**Subject: Submittal of Revised Ambient Air Quality Analysis  
Reliant Energy Osceola**

**Subject: Response to Request for Additional Information  
Reliant Energy Osceola, L.L.C. – PSD Permit Application**

Re: Request for Additional Information  
DEP File No. 0970071-001-AC (PSD-FL-273)  
Osceola Power Project - Three 170 MW Combustion Turbines

Figure 1  
Receptor Locations and Facility Layout

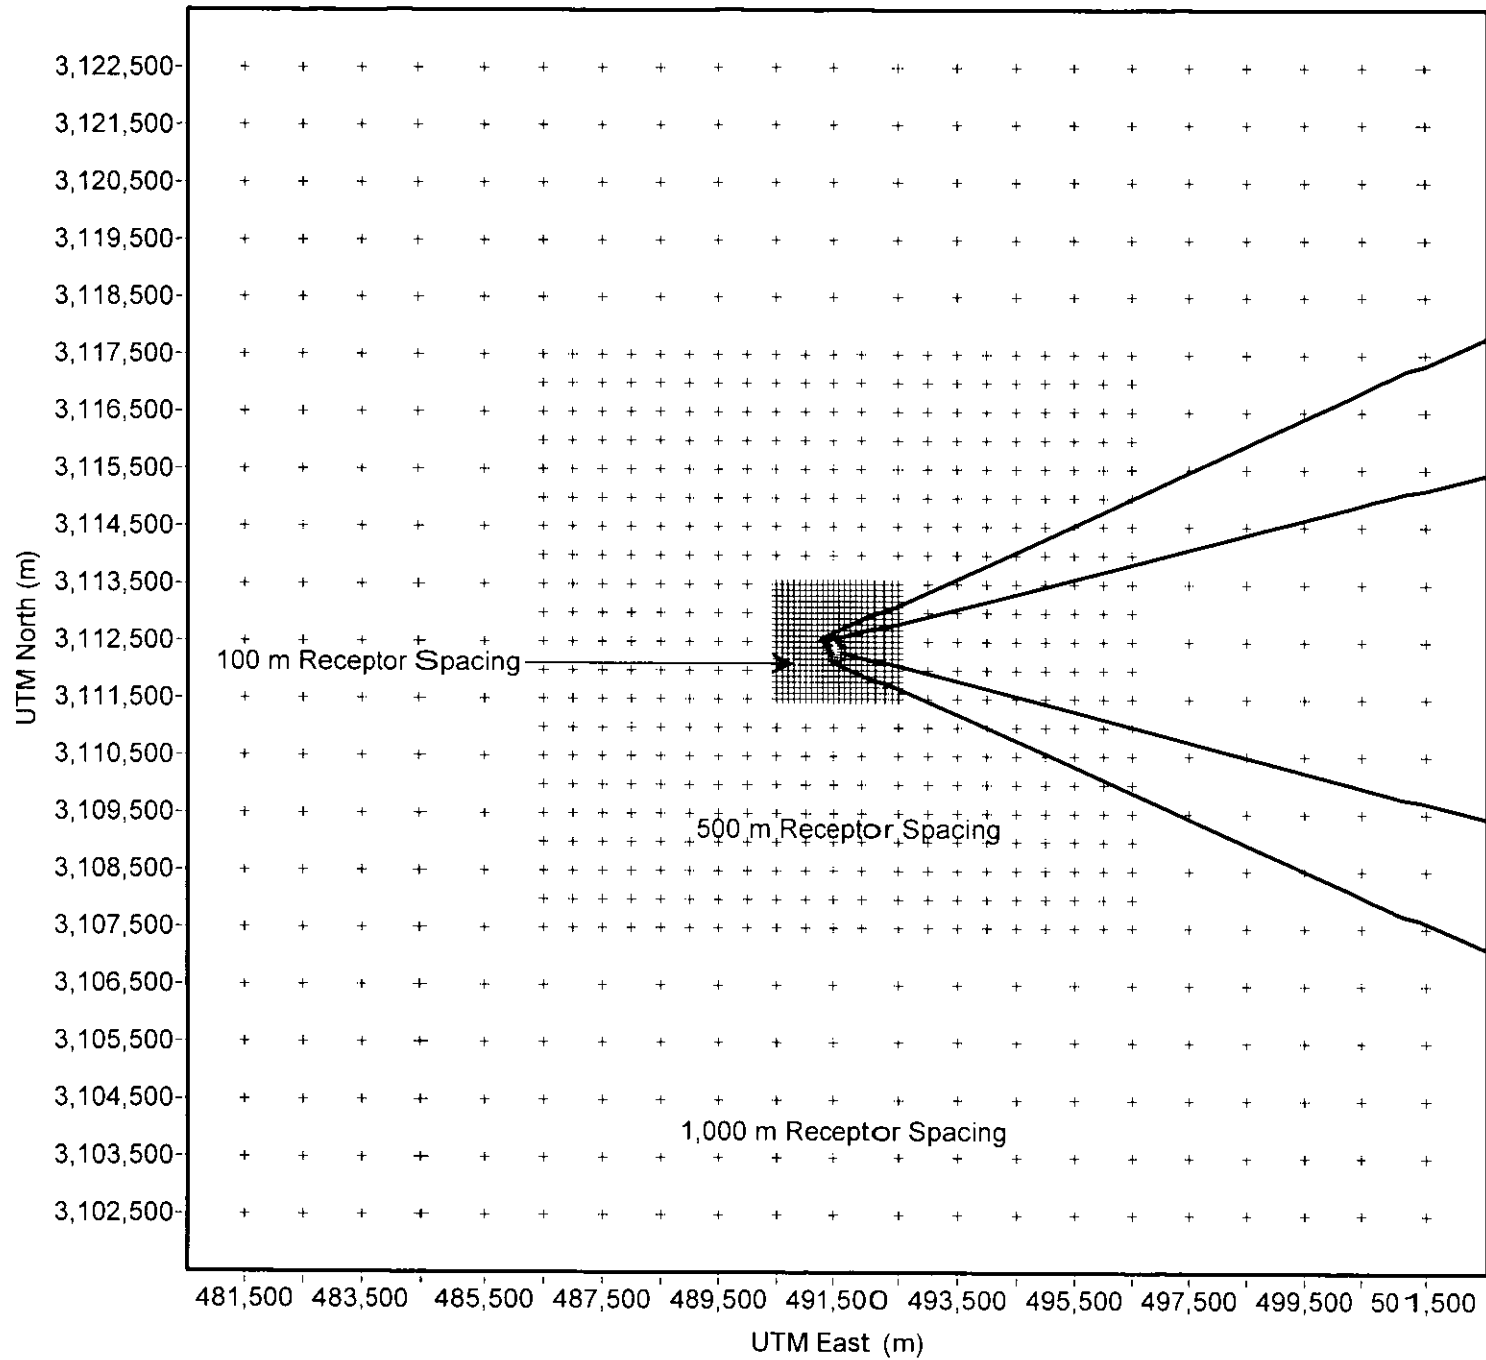
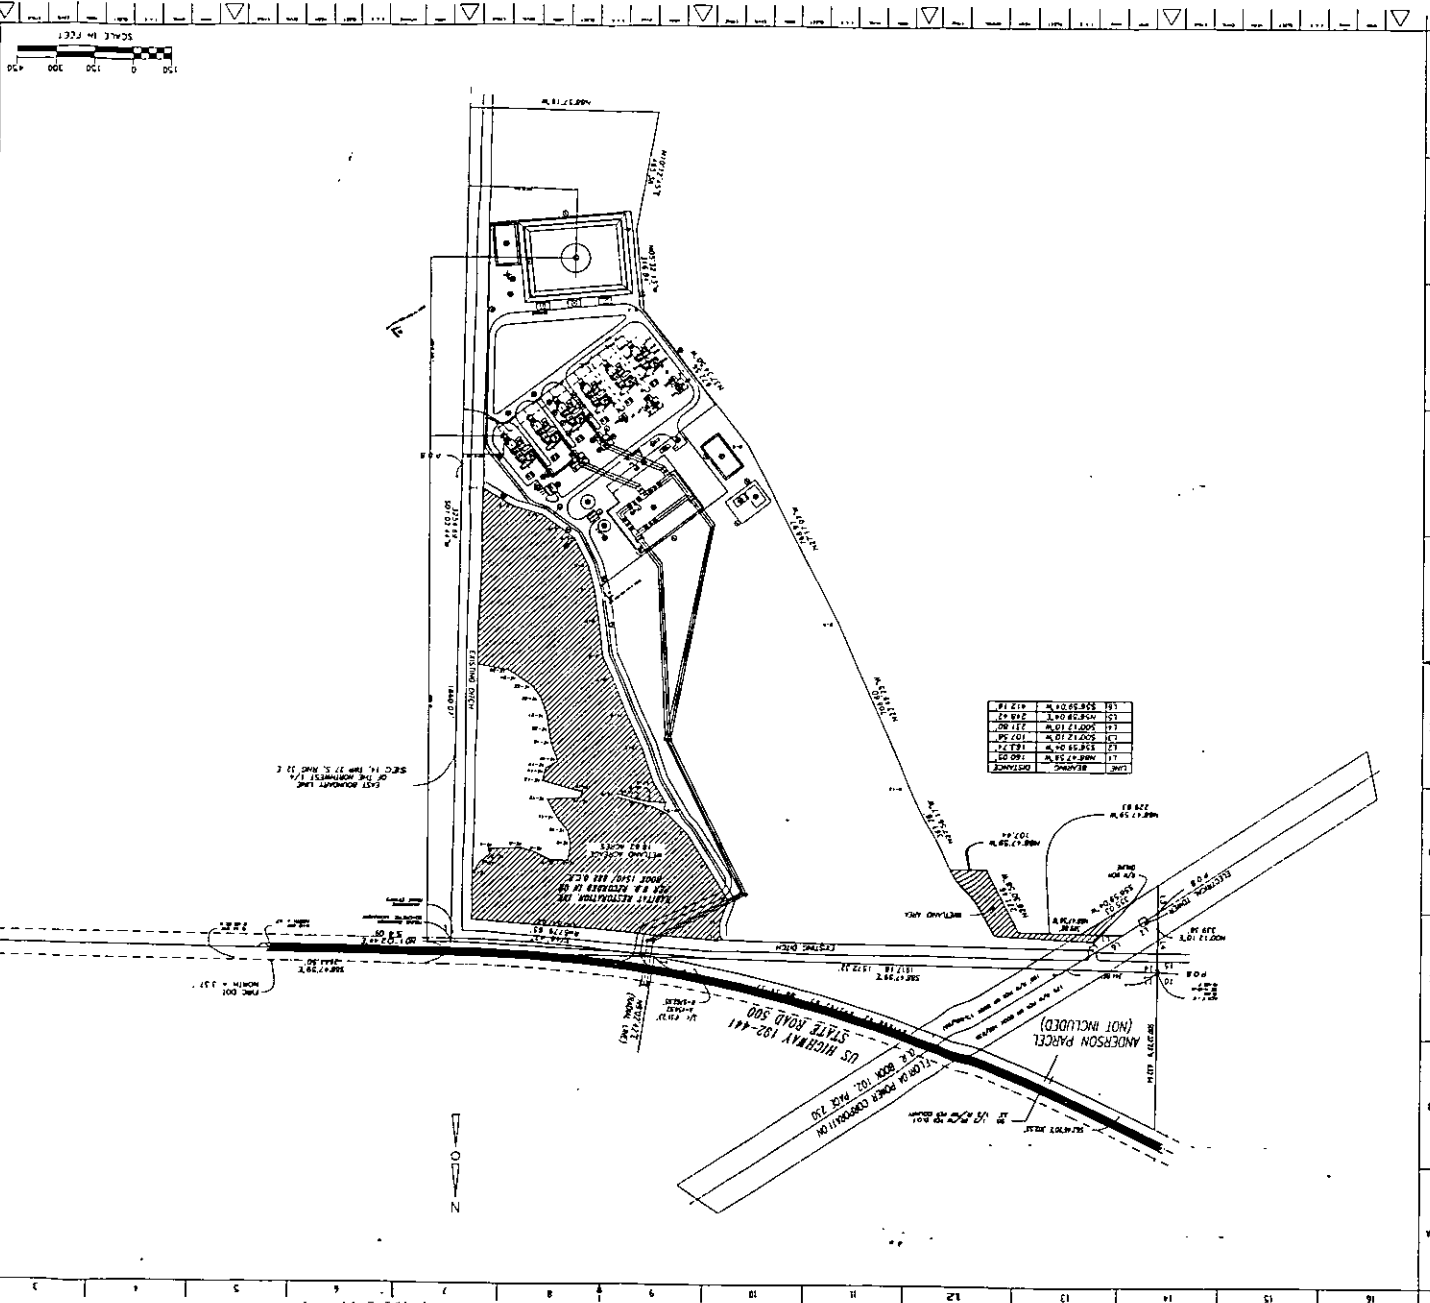
Recent changes to the proposed Reliant Energy Osceola facility have prompted additional air dispersion modeling to be performed for the proposed facility. These changes include modifications in the locations of on-site structures, fencelines and fenceline receptors, as well as the addition of a 9.8 MBtu/hr natural gas fired fuel-gas heater. The changes, and their associated impacts were assessed with the Industrial Source Complex (ISCST3) air dispersion model. The methodology of this air dispersion modeling, including specific air dispersion model defaults, terrain, and meteorological data, remain unchanged from the air dispersion modeling submitted in the original Construction Permit Application of July 30, 1999.

Due to recent engineering changes to the proposed project, the facility was relocated approximately 1,500 feet south of the originally proposed site, near the southeast corner of the property. Figure 1 illustrates the revised nested rectangular grid, fence line receptors, and the relative location of the emission sources and downwash structures, including the addition of the fuel-gas heater. It may be noted that this site arrangement is also rotated approximately 15-degrees to the left compared to the original site arrangement. The fuel gas heater is located in the northwest corner of the proposed site. Although the enclosed plot plan indicates the presence of six combustion turbines, the proposed Osceola facility will include only the three units located on the east side of the facility. All air quality impact analyses and other representations have been based on these three units only.

All sources, including the additional fuel gas heater, and operating scenarios modeled in the originally submitted air dispersion modeling analysis were again modeled in this new arrangement. Maximum model predicted concentrations for each pollutant and applicable averaging period are presented in Table 3. This table also provides the PSD Class II significant impact levels and required preconstruction monitoring levels. As the table indicates, the Project's maximum predicted concentrations for all pollutants from all sources and modeled operating scenarios are still less than the PSD Class II Significant Impact Level (SIL) for each pollutant and applicable averaging period. These results are similar to those found in the original air dispersion modeling analysis, where the maximum predicted modeled impacts also were less than the PSD SIL for all pollutants and applicable averaging periods. The changes to the proposed project will have an insignificant impact on the environment, and under the PSD program, no further air quality impact analyses are required. In addition, because the revised maximum predicted concentrations are all less than the PSD SILs for each pollutant and applicable averaging period, and are not significantly greater than the original predicted maximum concentrations, the originally submitted Additional Impacts Analysis and Class I Area Impact Analysis were not updated. Therefore, the original analysis and conclusions are valid.
